**ADDENDUM NO. 2
TO CONTRACT DOCUMENTS FOR THE
UVAS CREEK LEVEE REHABILITATION PROJECT
Project No. 62084001, Task No. 5175, Contract No. C0643**

ADDENDUM NO. 2
Santa Clara Valley Water District
UVAS CREEK LEVEE REHABILITATION PROJECT PHASE 1

**ATTACHMENT 2:
Revised Plan Sheets**

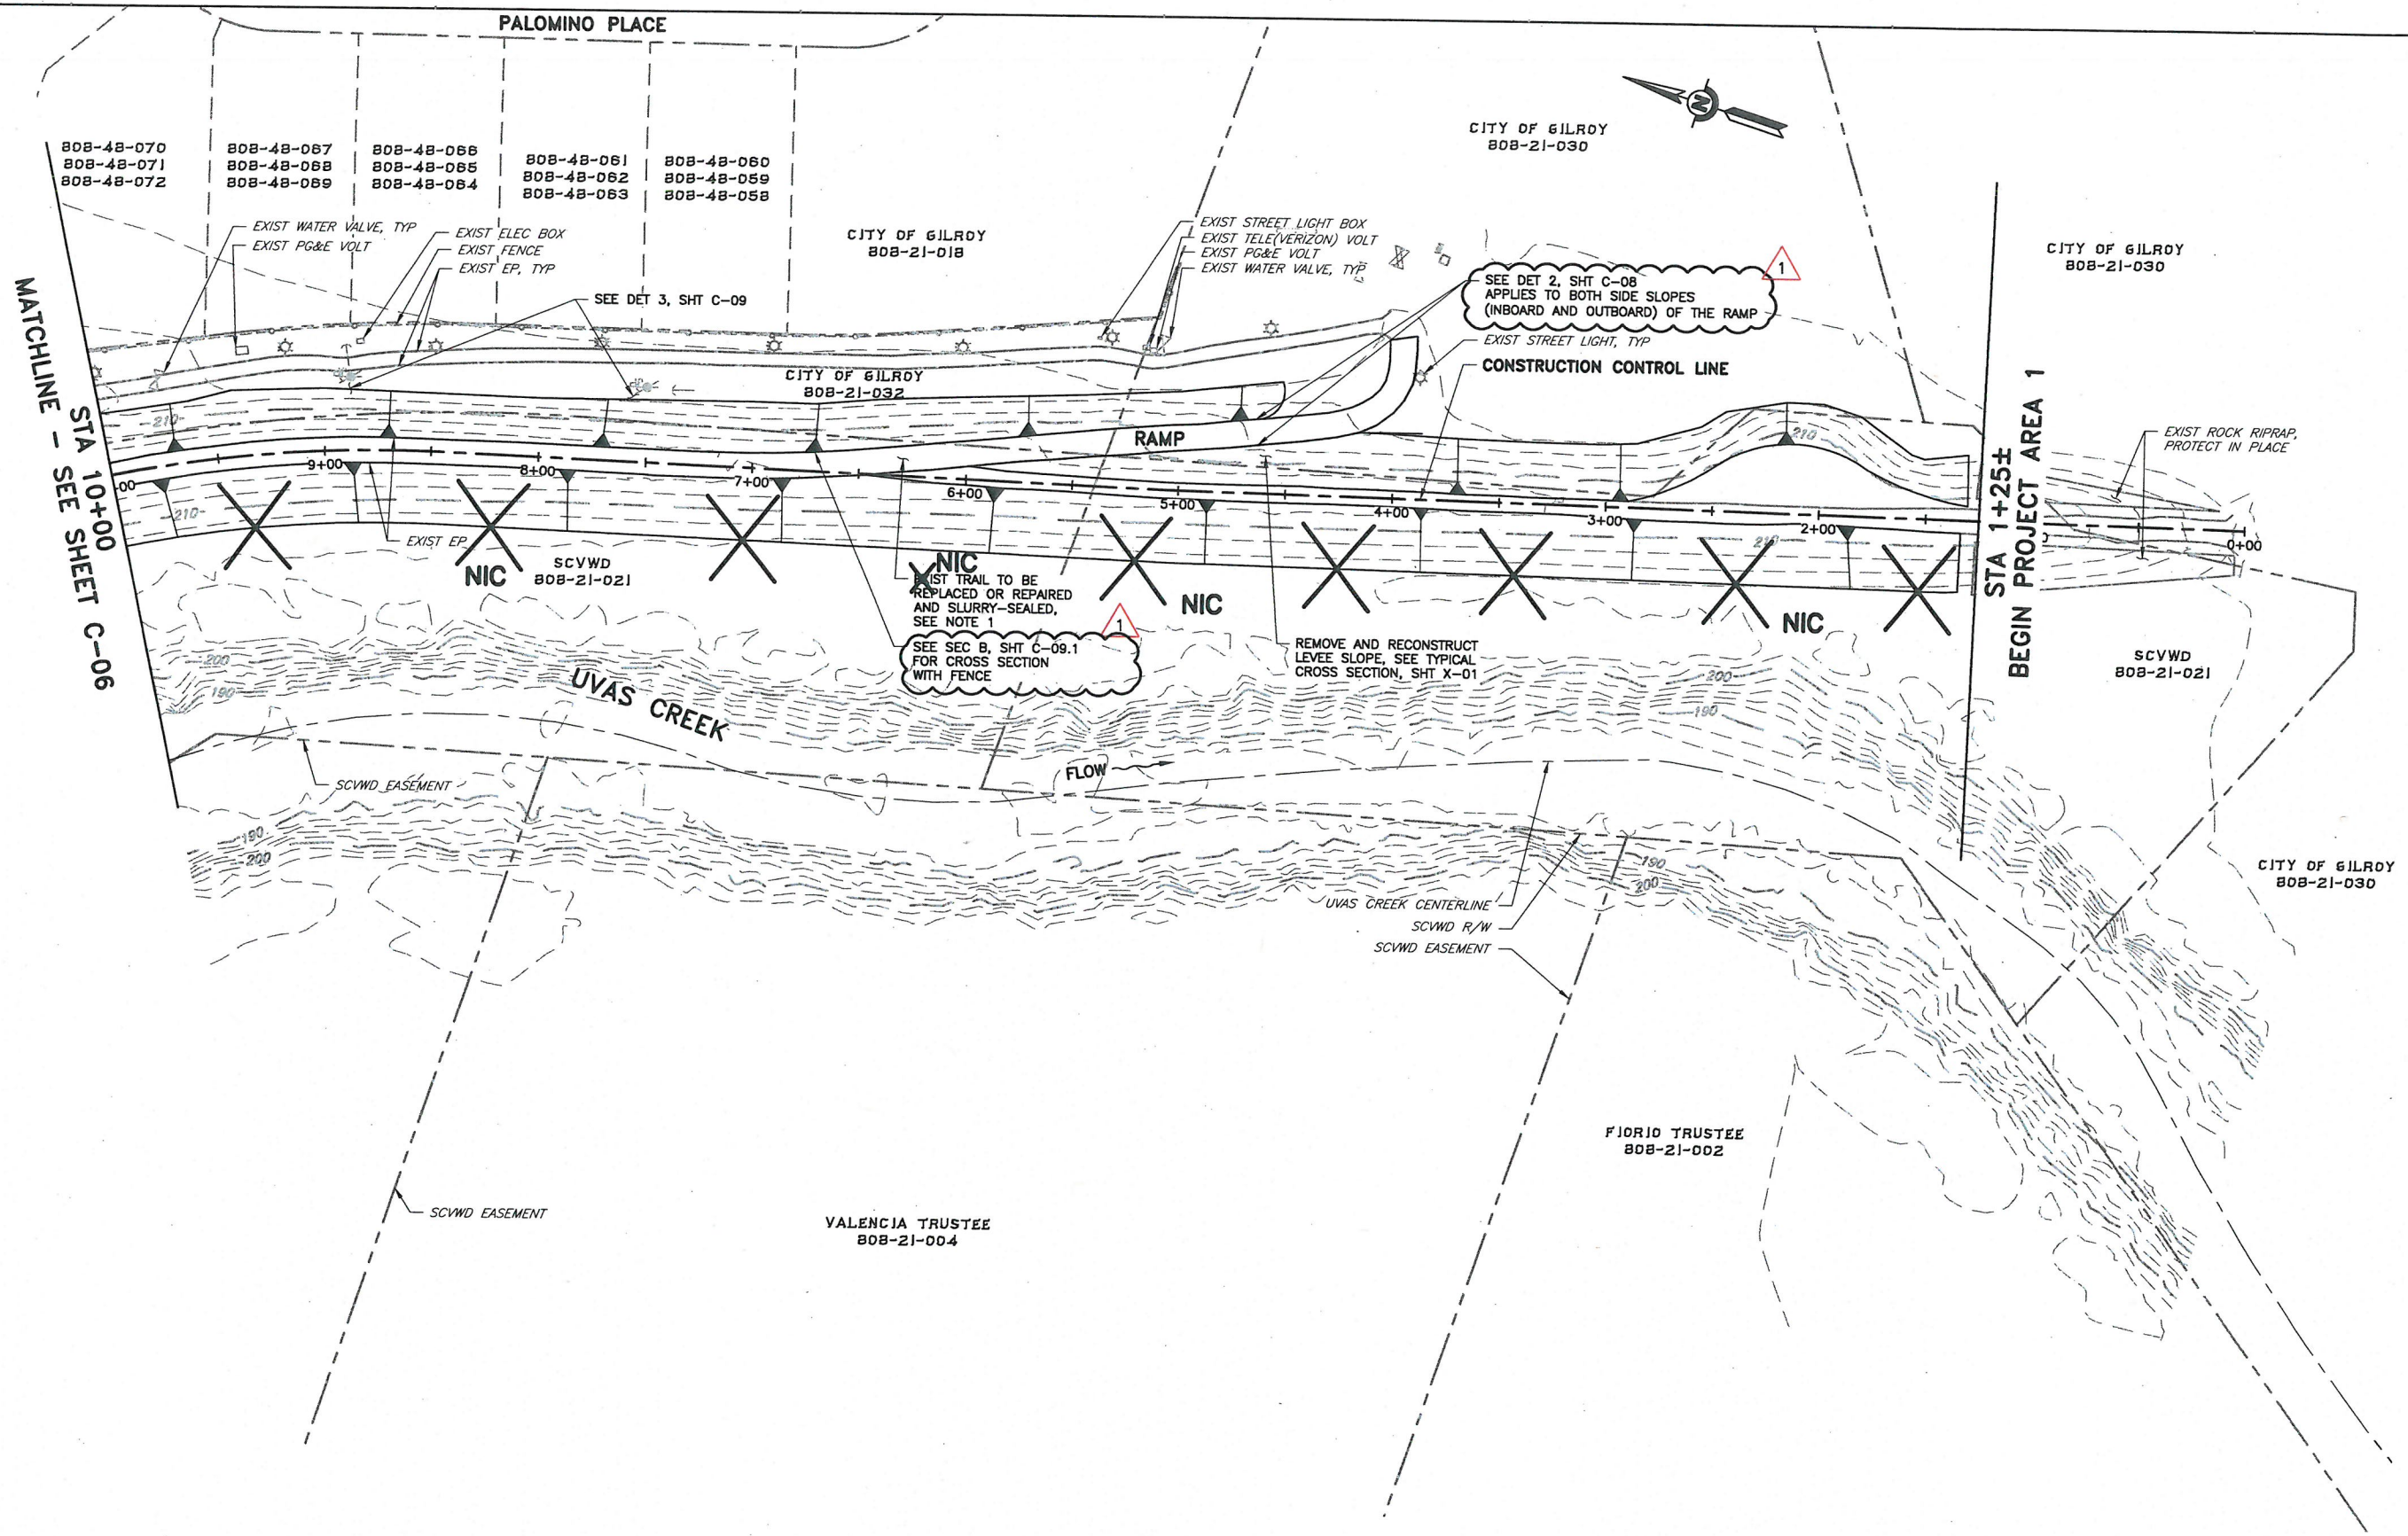
REV	DESCRIPTION	DATE	APPR	REFERENCE INFORMATION AND NOTES	DATE	ENGINEERING CERTIFICATION	PROJECT NAME AND SHEET DESCRIPTION:	SCALE AS SHOWN	PROJECT NUMBER
1	ADDENDUM #2 <div>ADDENDUM #2 07-31-2018</div>	7/18	TI	X NIC CITY TO DETERMINE LIMITS FOR AC CRACK REPAIR AND AC REPLACEMENT. 2. PER SPECS SECTION 16, CONTRACTOR SHALL ALLOW ACCESS TO HALF OF TRAIL DURING NON-CONSTRUCTION HOURS.	JULY 2018	<div><div>ENGINEERING CERTIFICATION</div><div>DESIGN T. IBARRA DRAWN S.K. / A.A. CHECKED R. NARSIM</div><div>7/10/2018</div><div>PROJECT ENGINEER DATE</div></div>	UVAS CREEK LEVEE REHABILITATION PROJECT MILLER AVENUE TO END OF LEVEE PLAN STA 10+00 TO 0+00	<div>0 1"</div> <div>BAR IS ONE INCH ON ORIGINAL DRAWING IF NOT ONE INCH ON THIS SHEET, ADJUST SCALES ACCORDINGLY</div>	62084001 SHEET CODE: C-07 SHEET NUMBER: 24 OF 30

DETAIL 1 TOP OF LEVEE REACH DETAIL
STA 4+00± TO STA 7+50± (PROJECT 1)
(LOOKING U/S)
SCALE: NTS

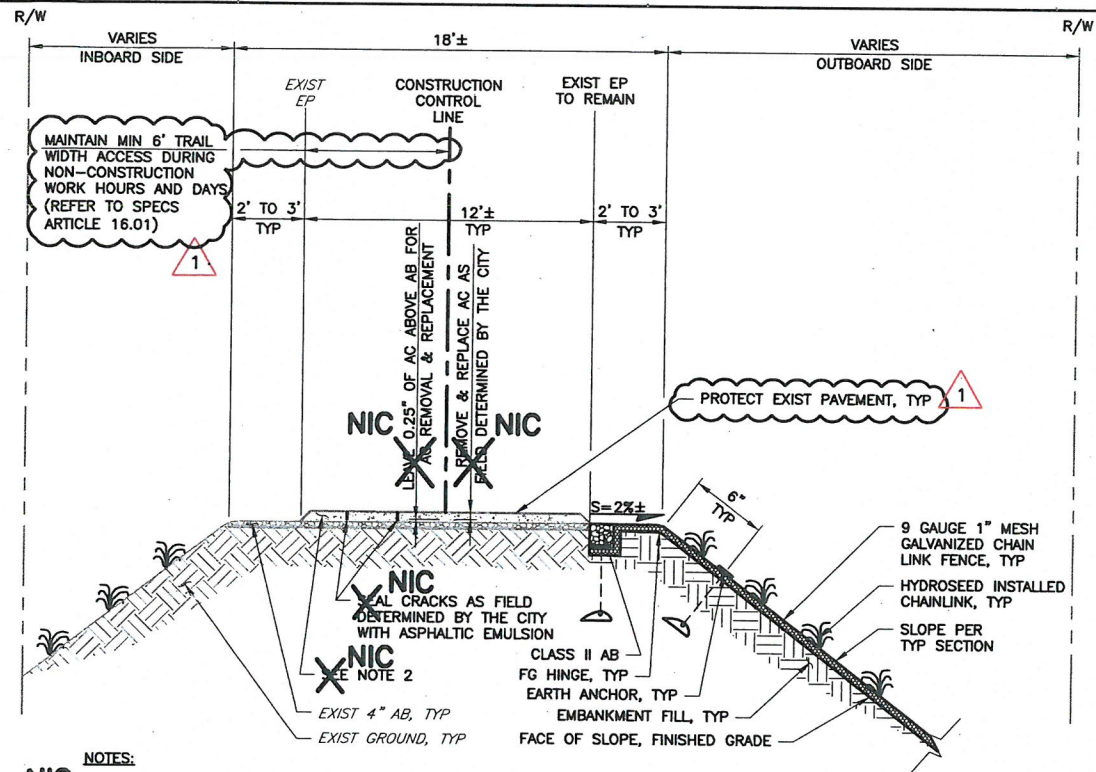
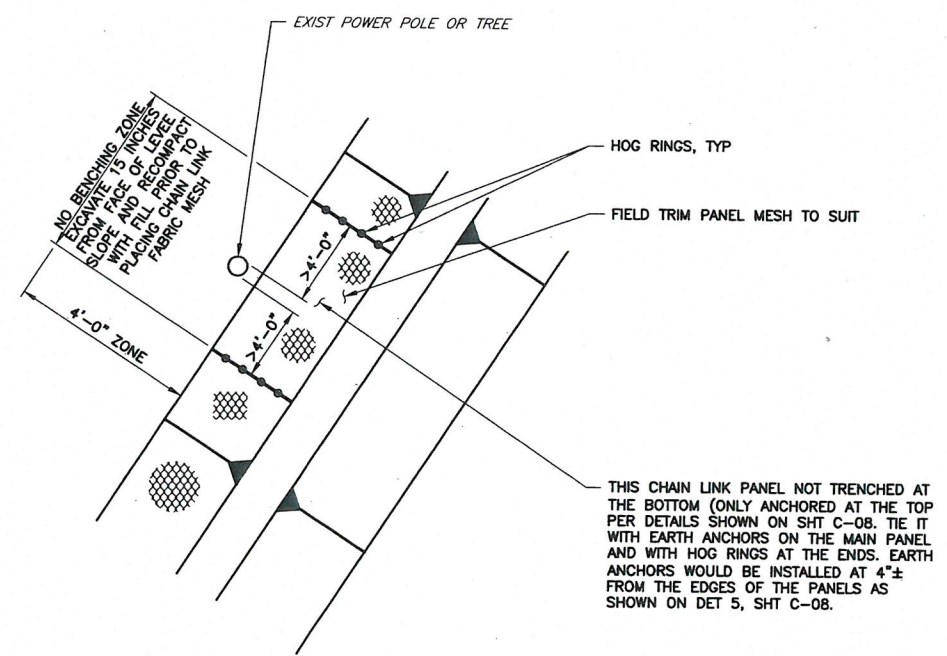
NIC X SLURRY SEAL & STRIPE AFTER SEALING CRACKS & REPLACING AC AS FIELD DETERMINED BY THE CITY.

NIC X EXIST 4"-5" TYPE A AC, TYP TO REMAIN IN PLACE EXCEPT FOR AREAS IDENTIFIED BY THE CITY REQUIRING PAVEMENT REPLACEMENT.
